Access Compliance Report

Public Rights-of-Way

(Curb Ramps)

Intersection ID: 31209	Main Street: CAPRINGTON_AV	Cross Street: CLACKWYCK_LN	Location: E
ADA ID: 24082760B863	Ramp Type: PerpDiag	Initial Pass/Fail: Fail	Overall Compliance: No
			Severity Score: 21.25

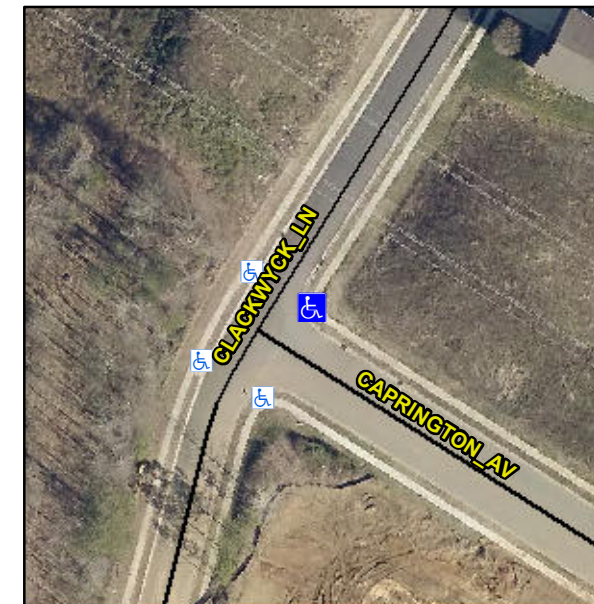
Not Found, R304.5.1, R304.5.3

Compliance	Description	Data	Compliance	Description	Data
N/A	Ramp Length (in)	48.0	Yes	Ramp Slope (%)	5.1
No	Ramp Width (in)	39.0	No	Ramp XSlope (%)	6.2
N/A	Flare Type LT	N/A	N/A	Flare Type RT	N/A
N/A	Flare Slope LT (%)	N/A	N/A	Flare Slope RT (%)	N/A
N/A	Flare Traversable LT?	N/A	N/A	Flare Traversable RT?	N/A
N/A	Landing Length (in)	N/A	N/A	DWS Provided?	N/A
N/A	Landing Width (in)	N/A	N/A	DWS Contrast?	N/A
N/A	Landing Slope (%)	N/A	N/A	DWS Length (in)	N/A
N/A	Landing X Slope (%)	N/A	N/A	DWS Full Width?	N/A
N/A	Landing Curb? (Y/N)	N/A	N/A	DWS Offset (in)	N/A
N/A	Shared Landing?	N/A			
N/A	Gutter Ponding?	N/A	N/A	Gutter Slope (%)	N/A
N/A	Gutter Lip Ht (in)	N/A	N/A	Gutter X Slope (%)	N/A
N/A	Painted X Walk1?	No	N/A	Painted X Walk2?	No
	X Walk 1 Direction	To NW		X Walk 2 Direction	To SW
N/A	X Walk 1 Width (in)	N/A	N/A	X Walk 2 Width (in)	N/A
	X Walk 1 Slope (%)	1.3		X Walk 2 Slope (%)	3.5
	X Walk 1 X Slope (%)	8.3		X Walk 2 X Slope (%)	6.5

Remove & Replace Curb Ramp With Two New Directional Ramps or Equivalent.
